KANSAS GAS AND ELECTRIC COMPANY

KMLNRC 85-058

Subj: Supplemental Information on Structural Steel Welding

RE: Evaluation of Structural Steel Welding at Wolf Creek - CAR No. 19

Fig a

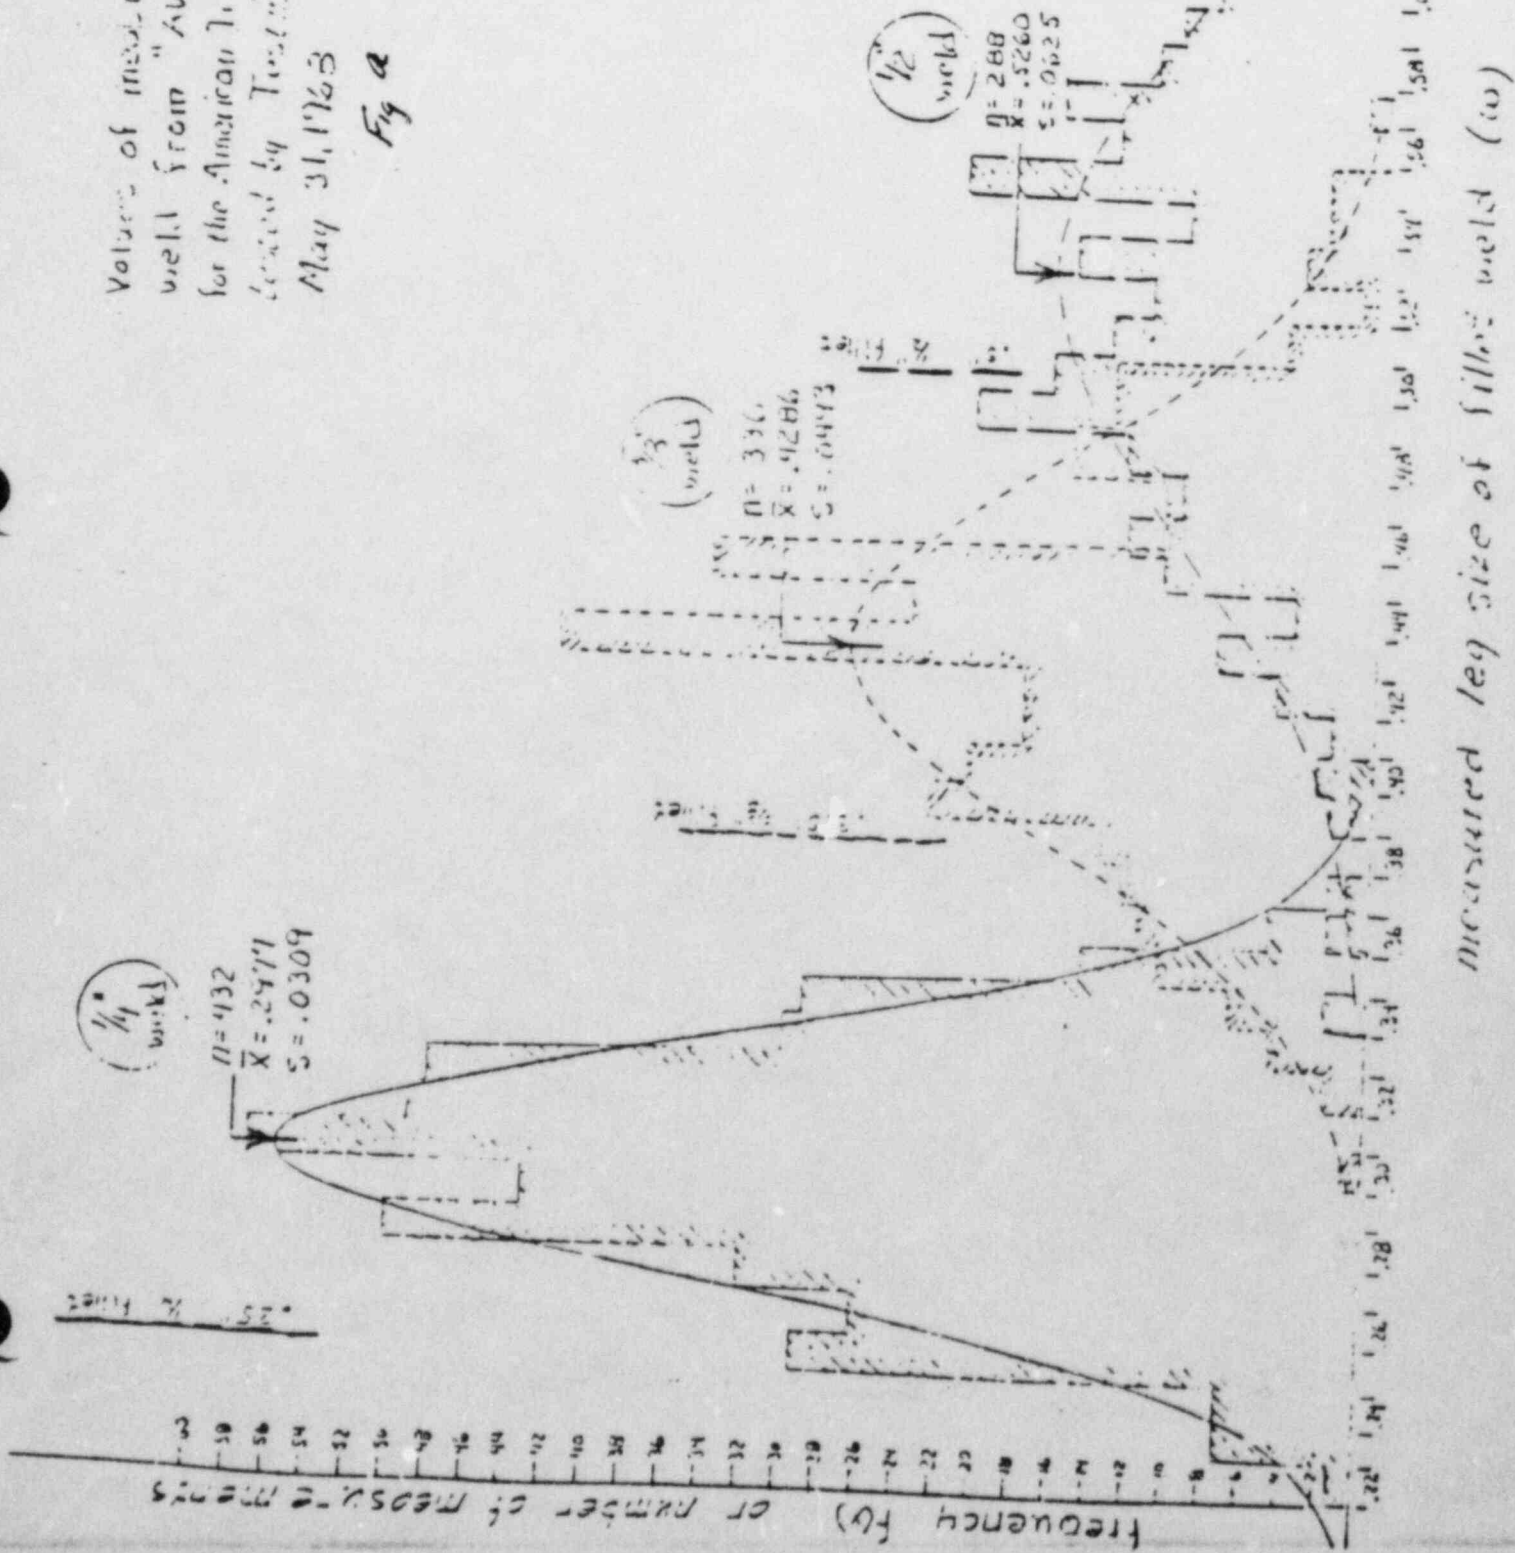
The general problem of weld size should be considered in terms of the expected statistical variation of weld dimensions in typical structural welding where the AISC allowable stresses are applicable. Enclosed are Fig. a through Fig. e showing the statistical variation of the 1/4 in., 3/8 in., and 1/2 in. welds used to develop the AWS and AISC specification provisions. These curves show the deviation in weld sizes that are to be expected with production welds. The variation of weld capacity that resulted from the AWS-AISC fillet weld study in 1968 was in part due to the variation in weld size that existed with the test sample. These were normal production welds, and similar deviations will exist with all welds. Figure 19.3 in Structural Steel Design shows the shear strength based on nominal weld size. It is clear that part of the reason for the variation in capacity is based on the weld size variation.

When a weld is found to be undersize by measurement, it is not significant unless it falls below the range indicated by the curves. The AWS Specification does not address the problem of deviations, and disposition of undersize welds must be done using the type of analysis that Bechtel has proposed. The fact that they are using actual weld sizes in calculations is conservative, since the specifications used the lower bound of the test data which included weld undersize.
